Certificate of Appropriateness

Property Description of work 4378 N. 25TH ST. Garden Homes Historic District

PTS ID 114550 COA: rebuild porch railings

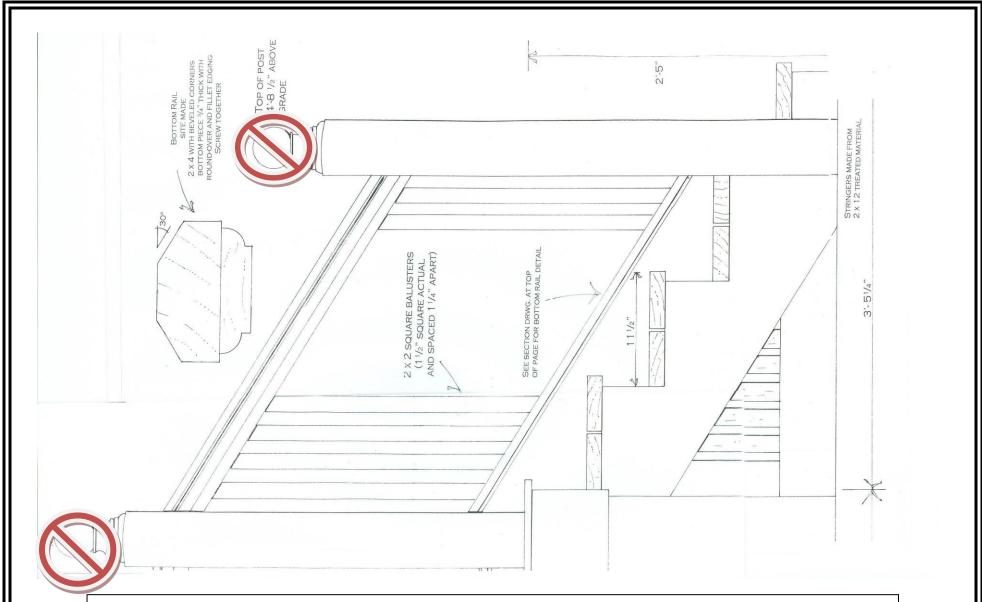
Original porch design as existing in 1988. Rebuild as shown with 2x2 square balusters, spaced 1.5" apart. Starburst design at center of each panel is required

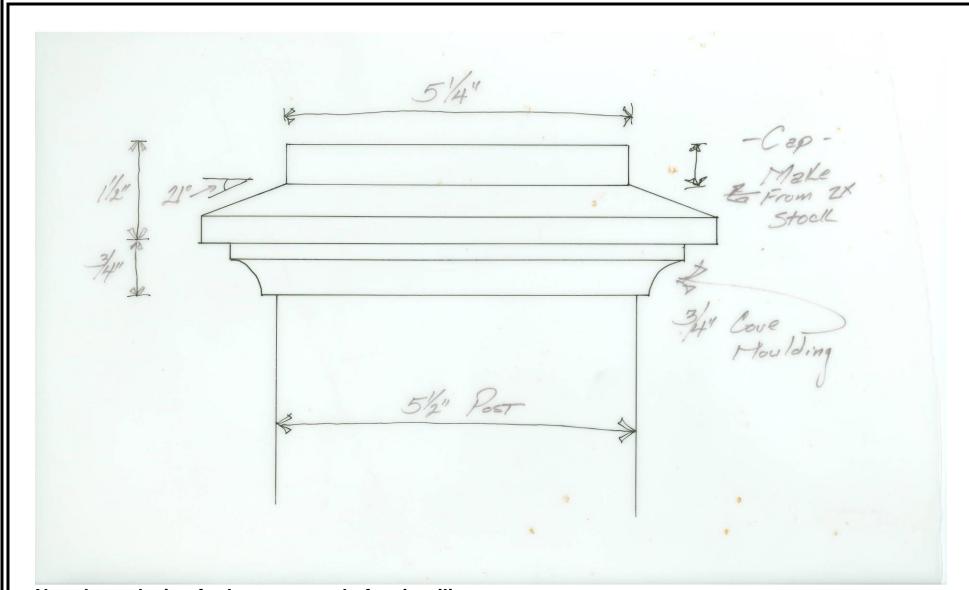
Example design for stair railing. A graspable handrail is required, but the balusters and bottom rail may e skipped on stair railing. Attach to existing column at top. Do not use ball newel cap. Newels shall be square. Use newel cap design on next page

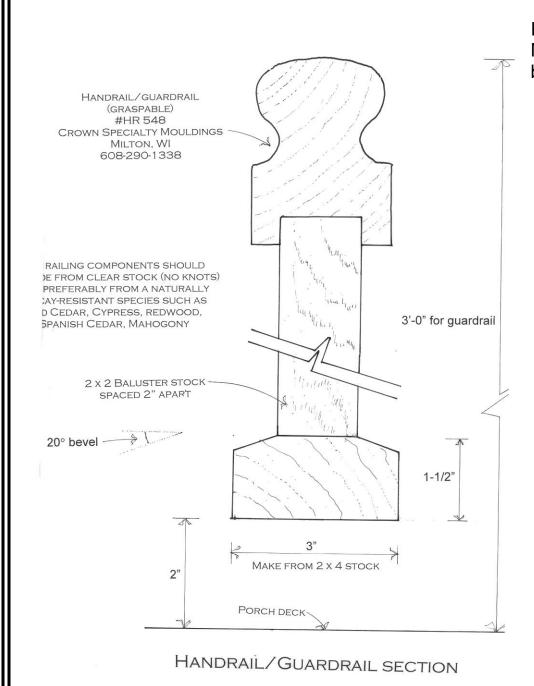
Newel cap design for bottom newel of stair railing.

Recommended handrail design for stair railing. May use this design for porch railing. Beveled bottom rail is required if bottom rail is replaced.

21.04(2)(a)5. HANDRAIL SHAPES

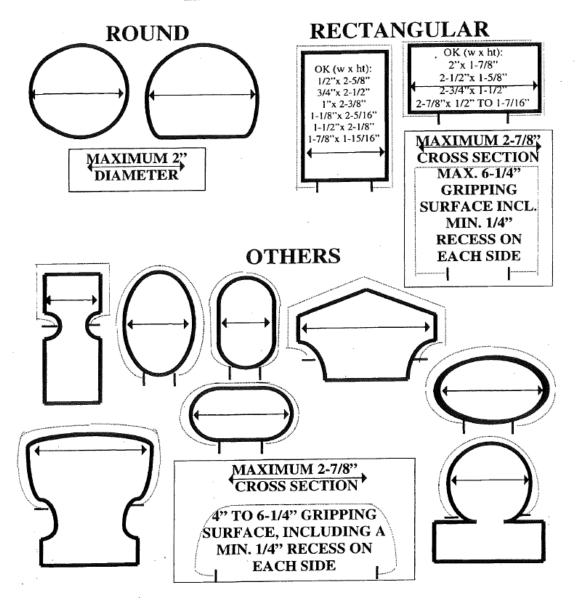
Alternate stair hand rail options. Do not use for porch top railing. Rectangular designs are strongly disouraged.
